Access Compliance Report

Public Rights-of-Way

Intersection ID: 18337	Main Street: E_WOODLAWN_RD	Cross Street: SELWYN_AV	Location: NW
ADA ID: 958AAB97BE92	Ramp Type: Perp	Initial Pass/Fail: Fail	Overall Compliance: No
			Severity Score: 21.25

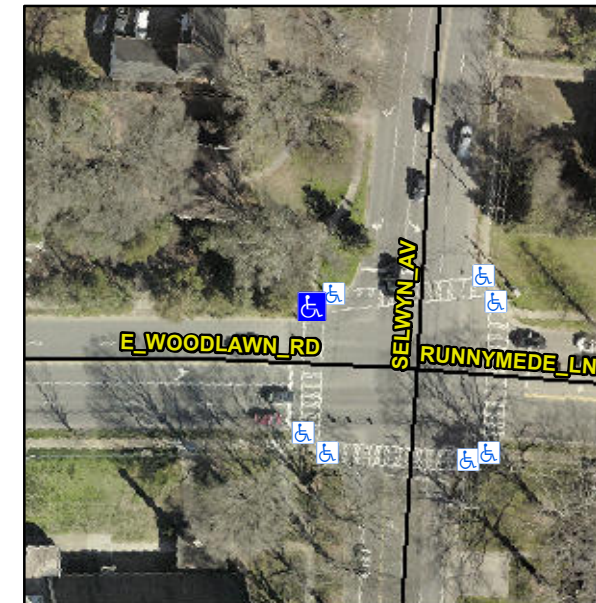
Not Found, R304.5.1, R304.2.2

Compliance	Description	Data	Compliance	Description	Data
N/A	Ramp Length (in)	87.0	No	Ramp Slope (%)	10.1
No	Ramp Width (in)	38.0	Yes	Ramp XSlope (%)	1.3
N/A	Flare Type LT	N/A	N/A	Flare Type RT	N/A
N/A	Flare Slope LT (%)	N/A	N/A	Flare Slope RT (%)	N/A
N/A	Flare Traversable LT?	N/A	N/A	Flare Traversable RT?	N/A
N/A	Landing Length (in)	N/A	N/A	DWS Provided?	N/A
N/A	Landing Width (in)	N/A	N/A	DWS Contrast?	N/A
N/A	Landing Slope (%)	N/A	N/A	DWS Length (in)	N/A
N/A	Landing X Slope (%)	N/A	N/A	DWS Full Width?	N/A
N/A	Landing Curb? (Y/N)	N/A	N/A	DWS Offset (in)	N/A
N/A	Shared Landing?	N/A			
N/A	Gutter Ponding?	N/A	N/A	Gutter Slope (%)	N/A
N/A	Gutter Lip Ht (in)	N/A	N/A	Gutter X Slope (%)	N/A
N/A	Painted X Walk1?	Yes	N/A	Painted X Walk2?	N/A
	X Walk 1 Direction	To S		X Walk 2 Direction	N/A
N/A	X Walk 1 Width (in)	110.0	N/A	X Walk 2 Width (in)	N/A
	X Walk 1 Slope (%)	1.0		X Walk 2 Slope (%)	N/A
	X Walk 1 X Slope (%)	1.4		X Walk 2 X Slope (%)	N/A

Remove & Replace Entire Ramp.
